Button issue

Gap issue

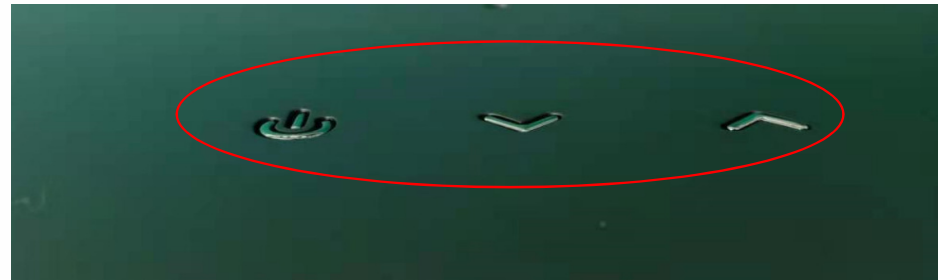
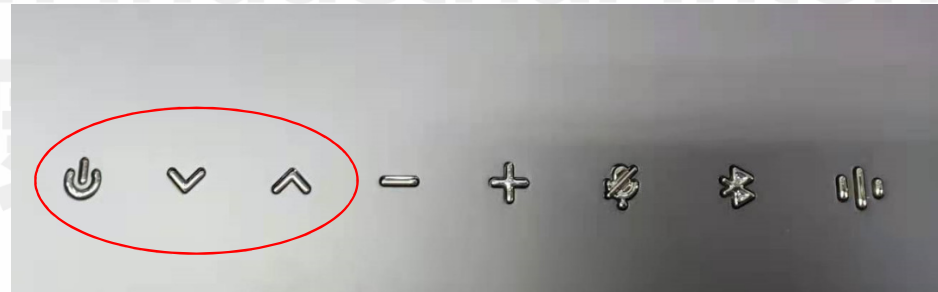
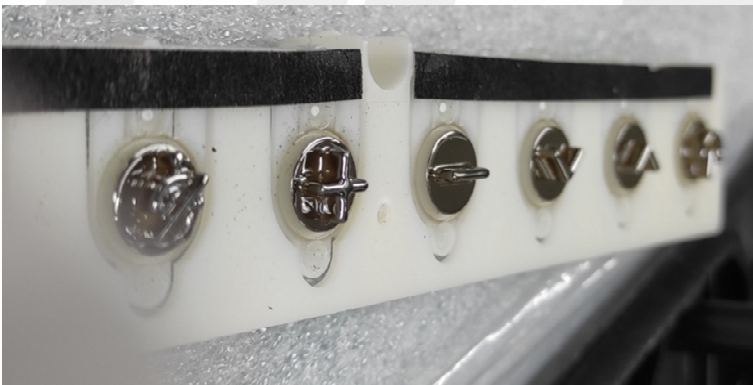
1. There are still burrs on the top cover after INKEL sorting.

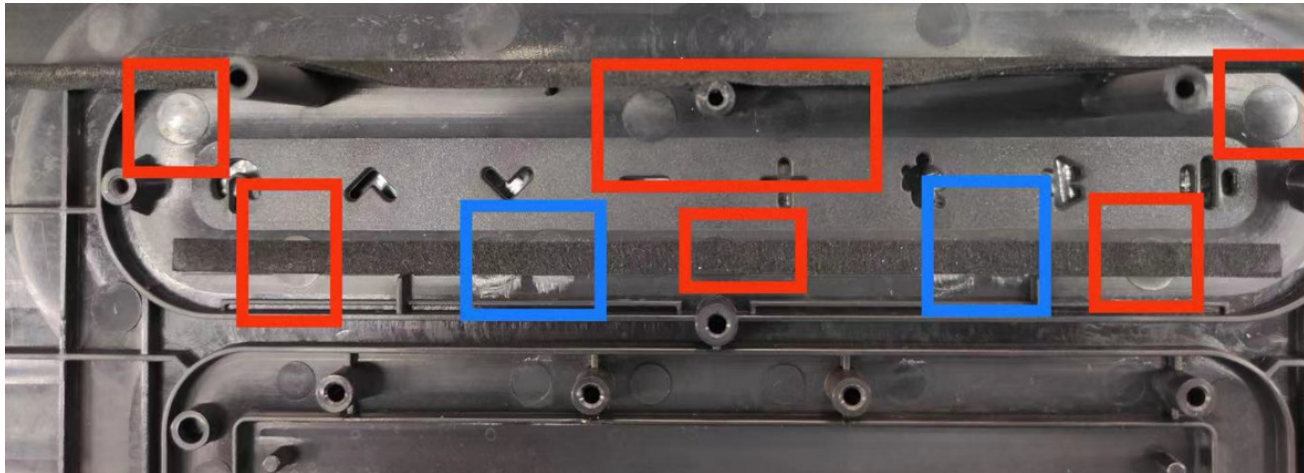
2. The button is crooked, so that the button won't pop up.

3. The height of the ejector marks is higher than the plane of the top cover, which will push up the button. And the appearance of the button will sink.

Gap of top cover and bottom cover screw boss

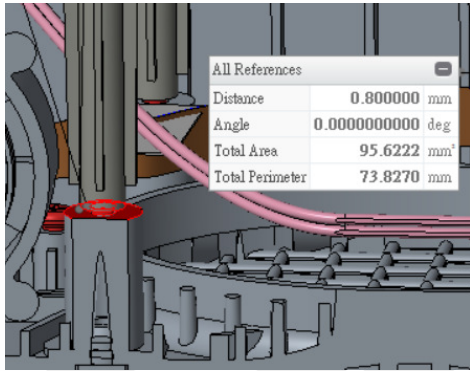
1. The gap of top cover and bottom cover screw boss is 0.8mm, and the thickness of the speaker on 3D model is 0.7mm. But the actual speaker thickness is 1.04mm, which causes the gap to out of spec. If we remove the speaker, the gap will be much smaller.
